PLANNING COMMISSION
Regular Meeting
Monday, April 8, 2019
6:00 PM
Christine Nuernberg Hall

Agenda

SIGN LAYOUT

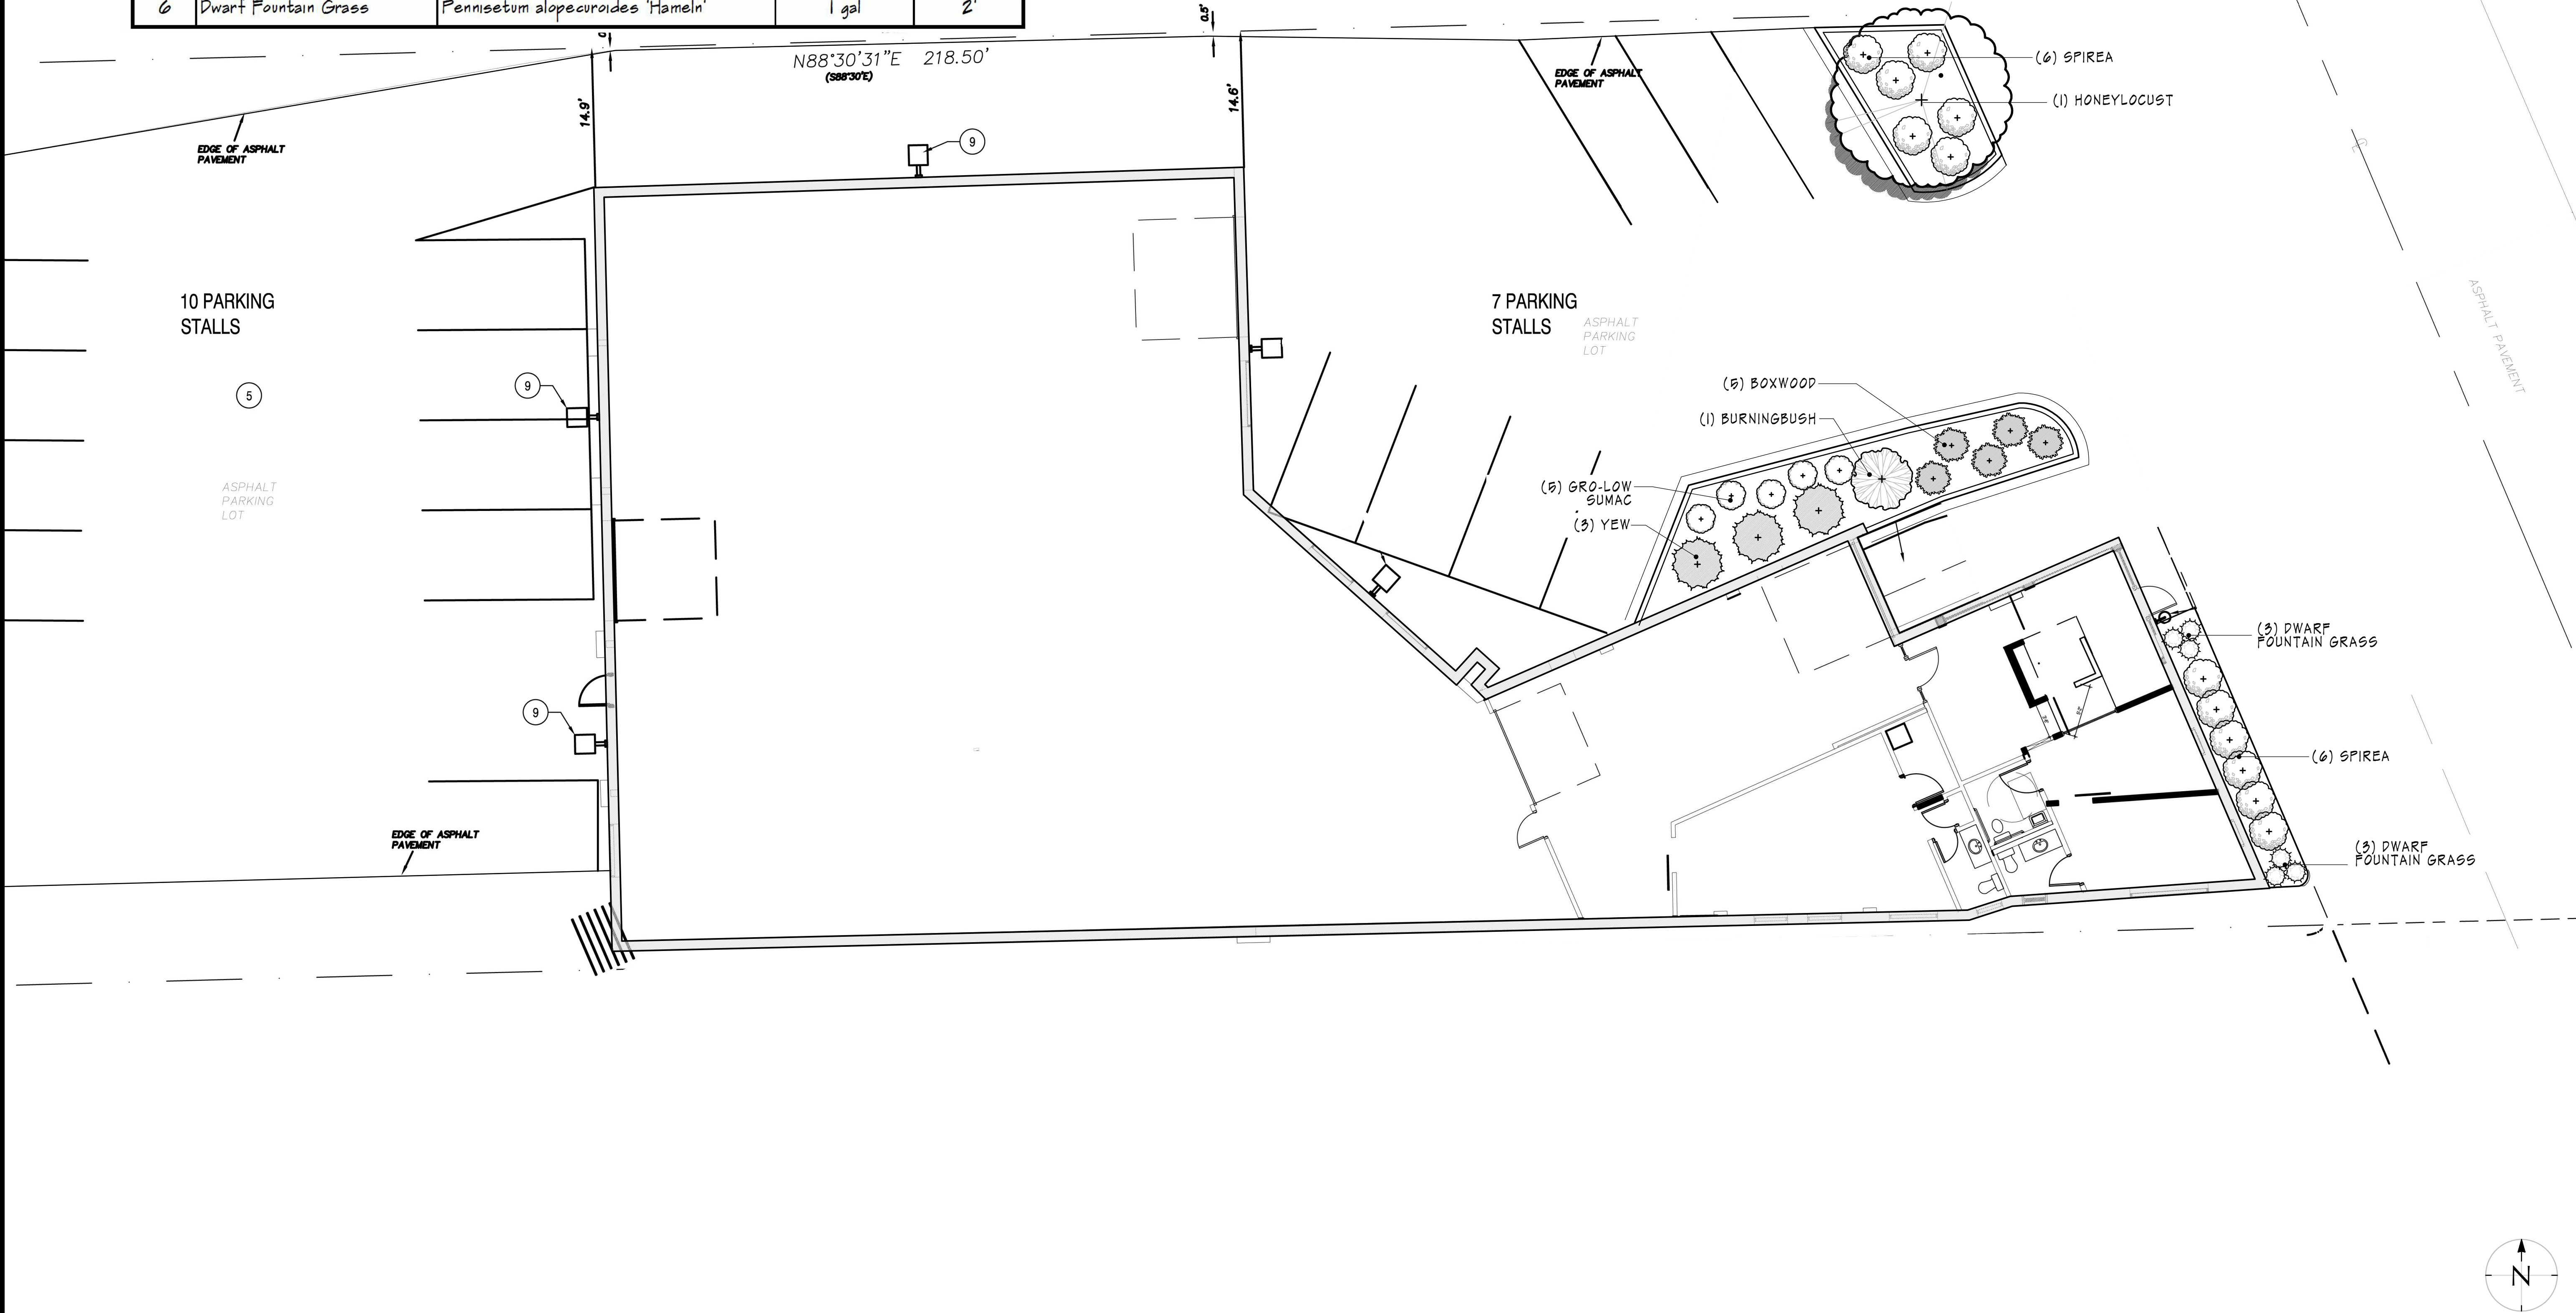
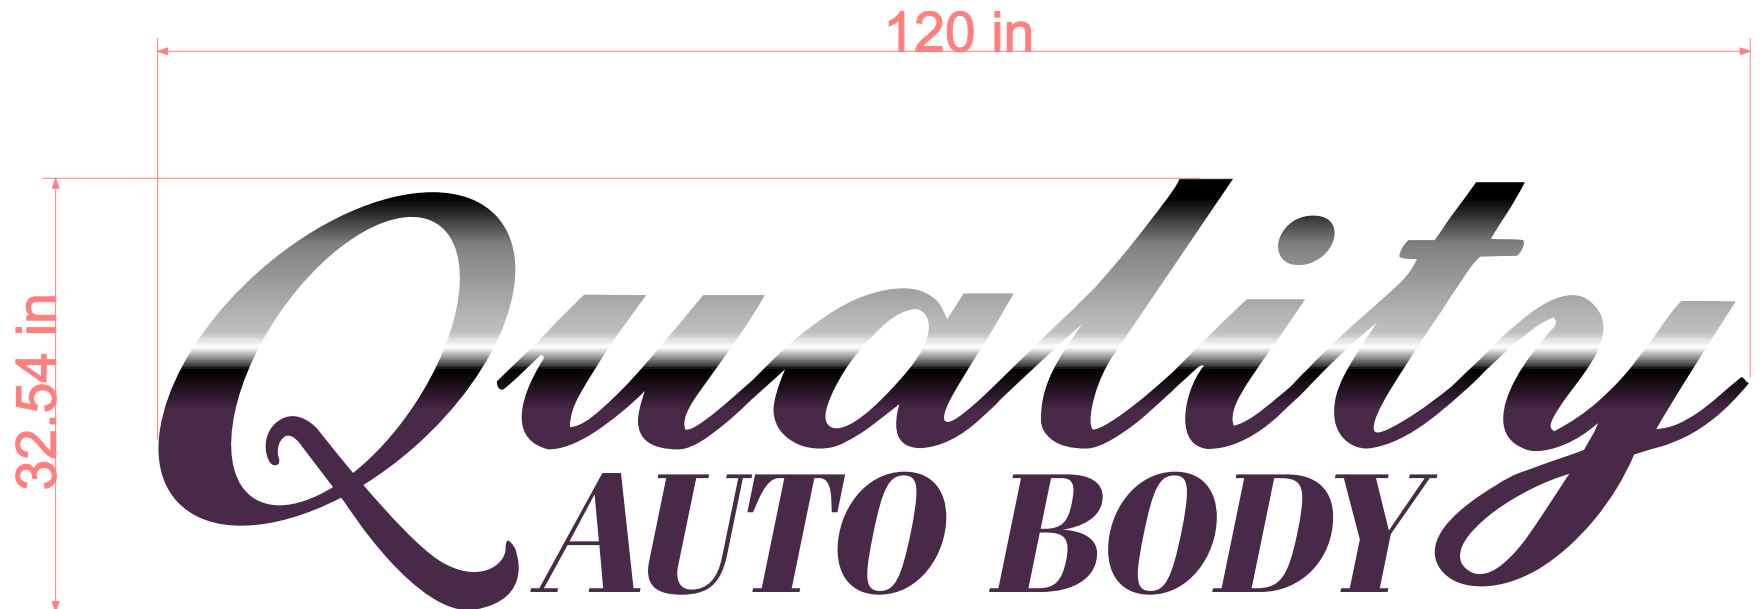
The proposed plan shows three wall signs for the building. There are wall signs shown on the east and north façade and a painted sign on the smokestack. For a single tenant building, the code allows one wall sign that does not exceed 2.5 percent of the wall area. In addition to the quantity of signs, the applicant is also requesting a waiver to the size of the signs. Based on the area of the

This request is similar to the request made by Associated Bank on Port Washington Road. As with the Associated Bank request, staff does not support the waiver for the two wall signs. Staff believes the applicant has other options to provide visibility to traffic in both directions. In the Town Center zoning district, the applicant has the option of a projecting sign. This type of sign would provide maximum visibility to traffic in both directions. If the applicant prefers the wall sign design, staff would not support the waiver for both signs. With regard to the size of the wall sign, staff is supportive of the waiver on either the north or east elevation. The size and shape of the building only permits a relatively small sign size. If the building was multi-tenant, the code would allow the signs to up 30 square feet in area. The 27 square foot sign is at an appropriate size and scale when compared to the overall building size.

5. The proposed Honey Locust shall be 3” in diameter at planting.
6. There shall be one wall sign located on either the north or east elevation not exceeding 27 square feet.

Plan View
Scale - 1" = 10ft

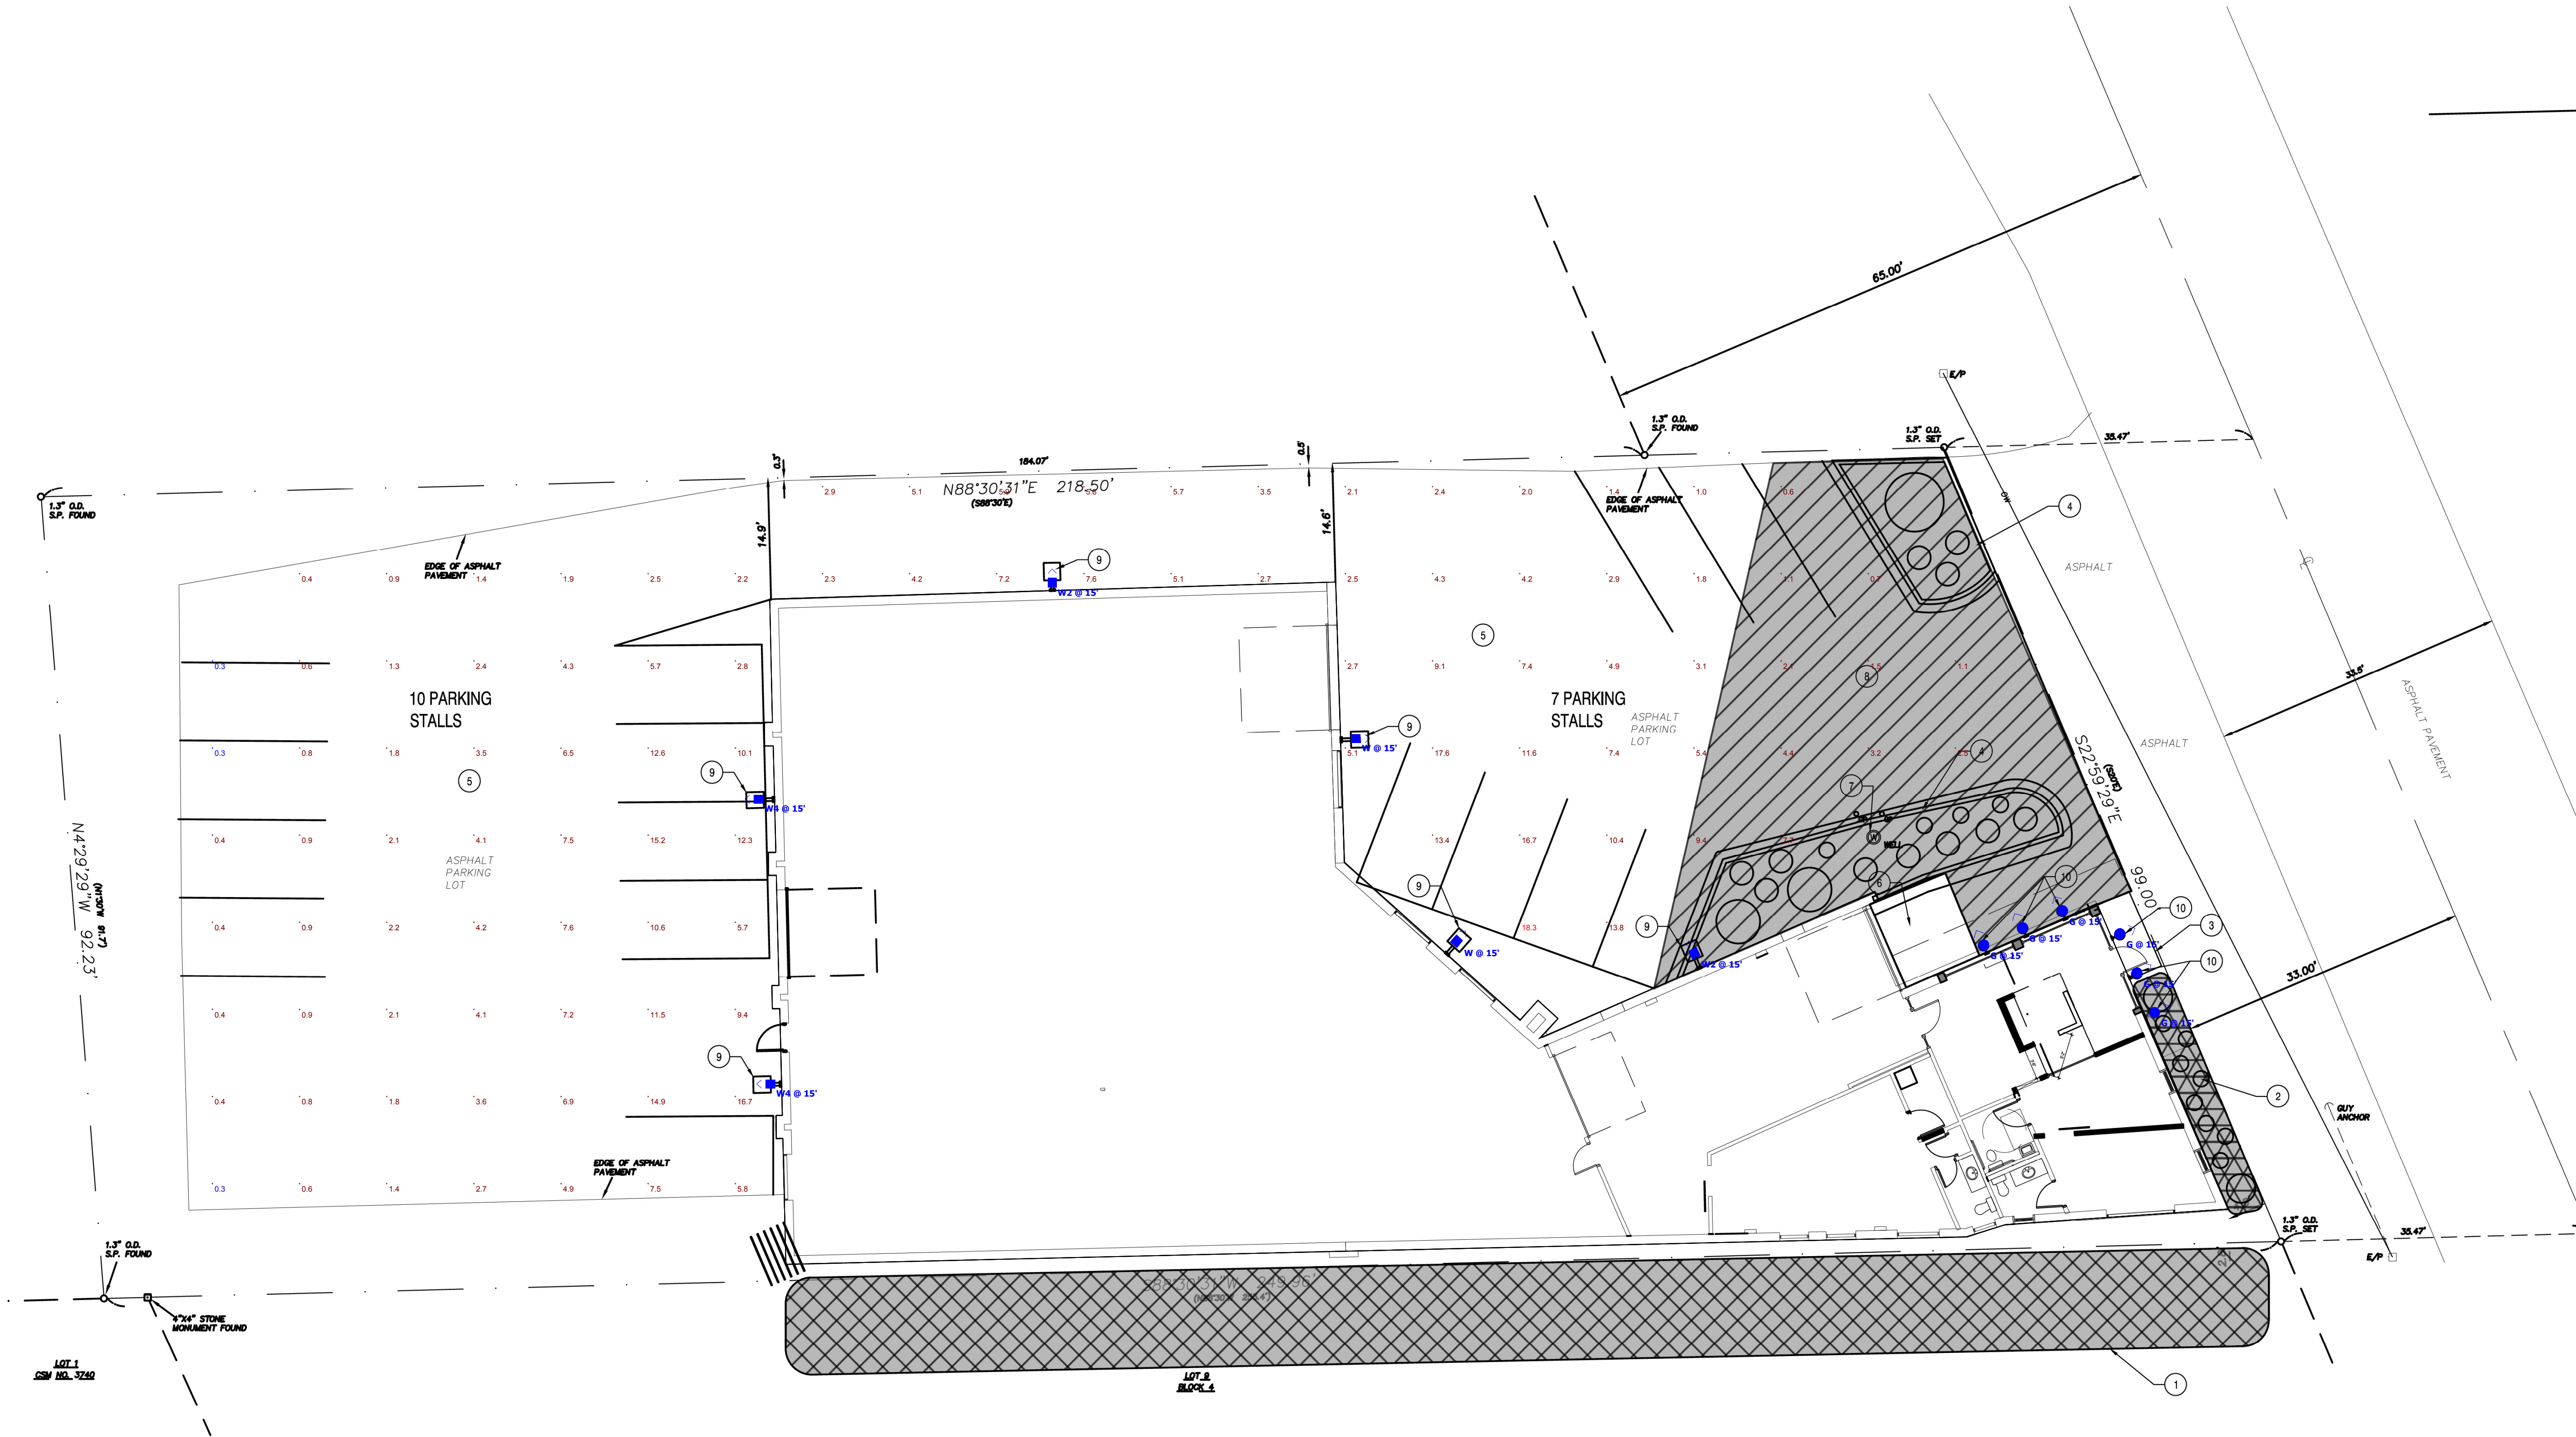
The applicant is proposing to add a number of wall packs around the building. The wall packs are full cutoff in accordance with the lighting code. The dispersion plan shows light trespass levels at the property line that exceed the code requirement. As a condition of approval staff will require that the light level at the property be reduced to achieve compliance with the code. The plan also shows six decorative gooseneck wall sconces on the east elevation that will accentuate the entranceway and the wall signage.

3. The dumpster shall be screened with an enclosure to be reviewed and approved by staff.
4. The lighting plan shall be updated to show light trespass levels in compliance with the lighting code.
